RE: 1997-98 Reclamation Performance Bonds for Mountain Cements Non Coal Permits

**RE: 1997-98 Annual Report Review of Reclamation Performance Bond for Permits
297C, 298C, 299C, 300C, 604s, 605s, and 658, Mountain Cement Company**

SUBJECT: 1997-98 Annual Report Review, Reclamation Performance Bonds for 297C, 298C, 299C, 300C, 604s, 605s, and 658, Mountain Cement Company

RE: 1997-98 Annual Report Reviews for Permits 297C, 298C, 299C, 300C and 658, Mountain Cement Company (MCC)

Annual Report Map	
WEAVER LIMESTONE QUARRY	
658	
March 1, 1997 to February 28, 1998	
Mountain Cement Company	
5 Sand Creek Rd	
Laramie, Wyoming	
(307) 745-4879	
SCALE 1" = 500'	
CONTOUR INTERVAL 20'	
Drafted 2/20/97 DL Revised 2/26/98 SN

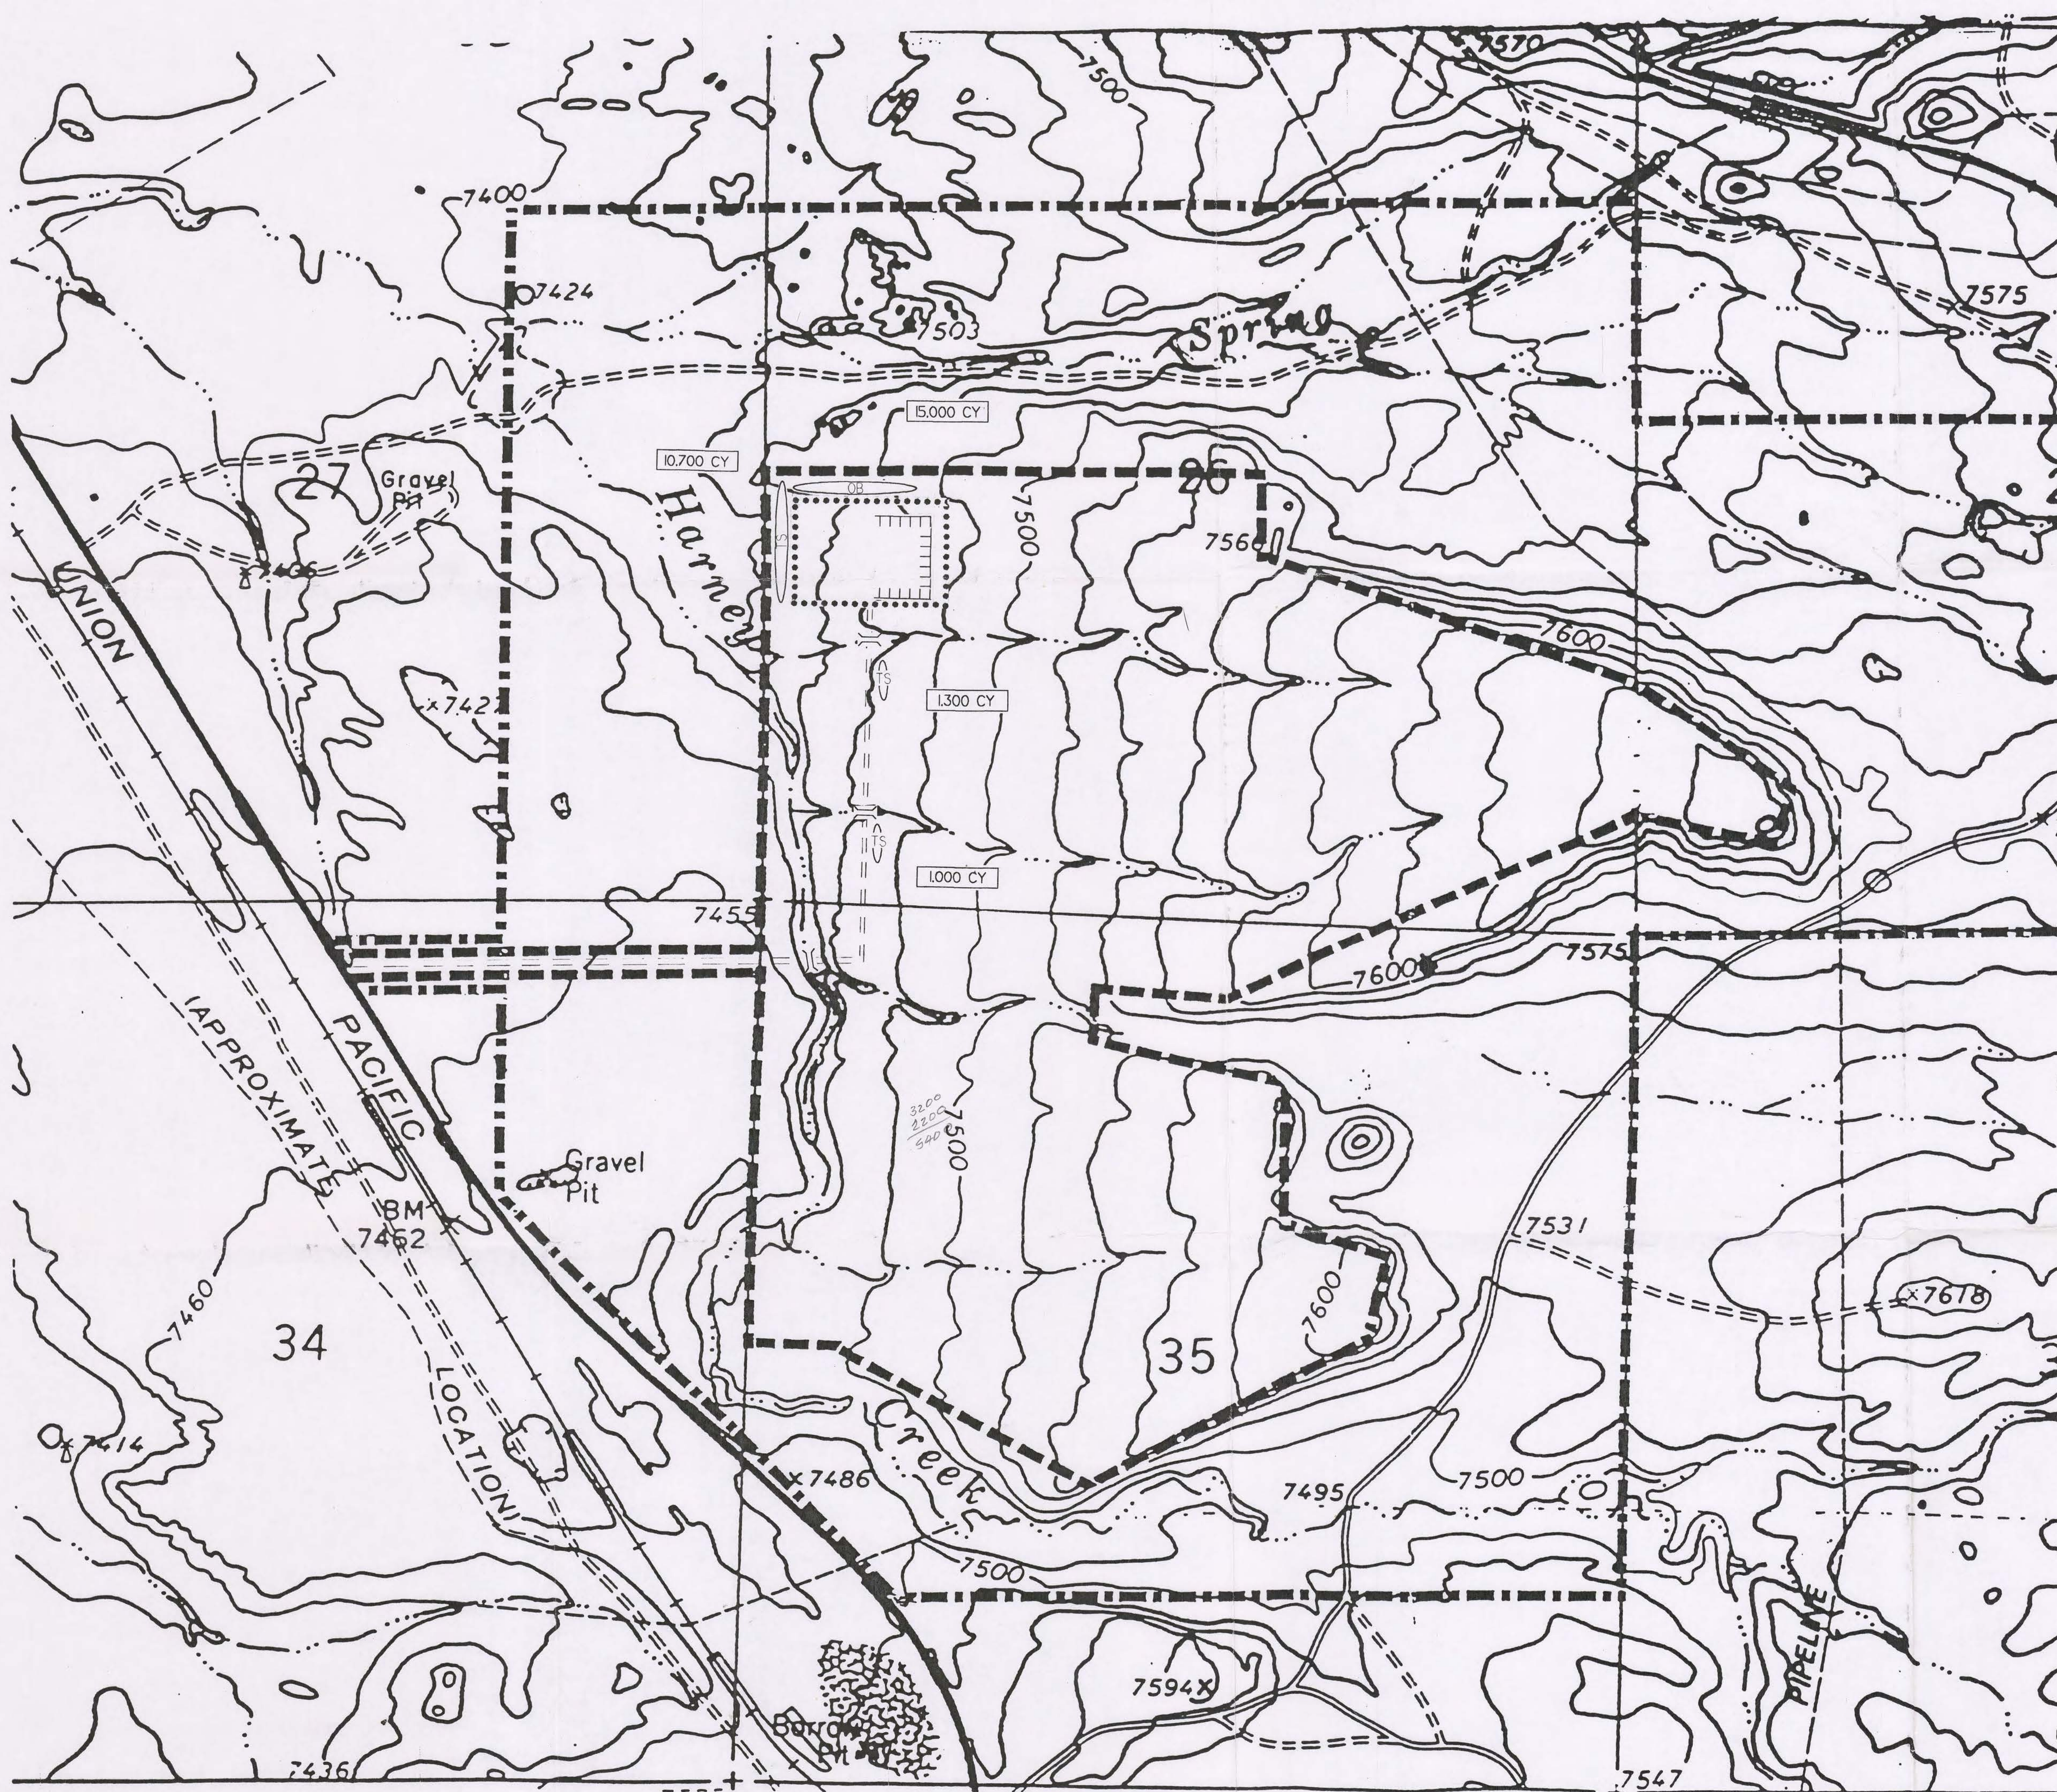
The Mountain Cement estimate varies from LQD's estimate with regard to Harney Creek crossing removal and reconstruction. Also, it is requested that MCC furnish more information in the future on highwall length and depth.

The LQD bond estimate is \$48,900.00 and represents an **increase of \$26,900.00** from the present bond held in the amount of \$22,000.00.
